RE: Letter of Intent- MVEA Eastonville 2

Mountain View Electric Association, Inc (MVEA) will be constructing a 12.5 kV underground electrical distribution feeder line running along the Eastonville Road from Latigo Boulevard to Londonderry Drive. The underground installation will be approximately 2.7 miles in length and will begin at the Meridian Electric Substation near the intersection of Eastonville Road and Latigo Boulevard. The installation will run south parallel to Eastonville Road offset a distance of approximately 55' from the road. The line terminates south of Londonderry Drive where it will tie-in to existing conduit.

VICINITY/SITE MAP OF NEW UNDERGROUND ELECTRICAL DISTRIBUTION LINES
*NOT DRAWN TO SCALE

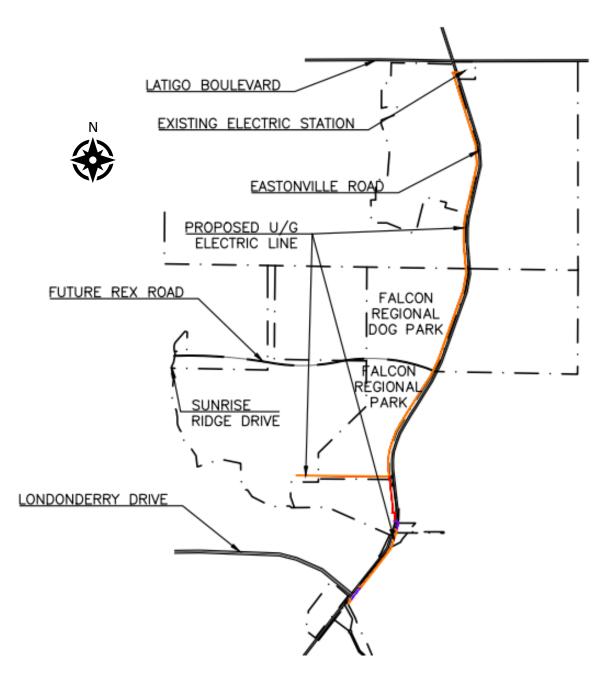
- Please provide the total area of land disturbance and the scope of work that sums to the total area of land disturbance.
- Applicant is required to apply for a Work-in-ROW permit from El Paso County Department of Public Works since Eastonville Road is a county maintained road. Please confirm applicant will/has applied for a Work-in-ROW permit.
- FYI: Per ECM K.1.8 all disturbed road gravel surfaces shall be repaired to ECM standards listed in the section above.
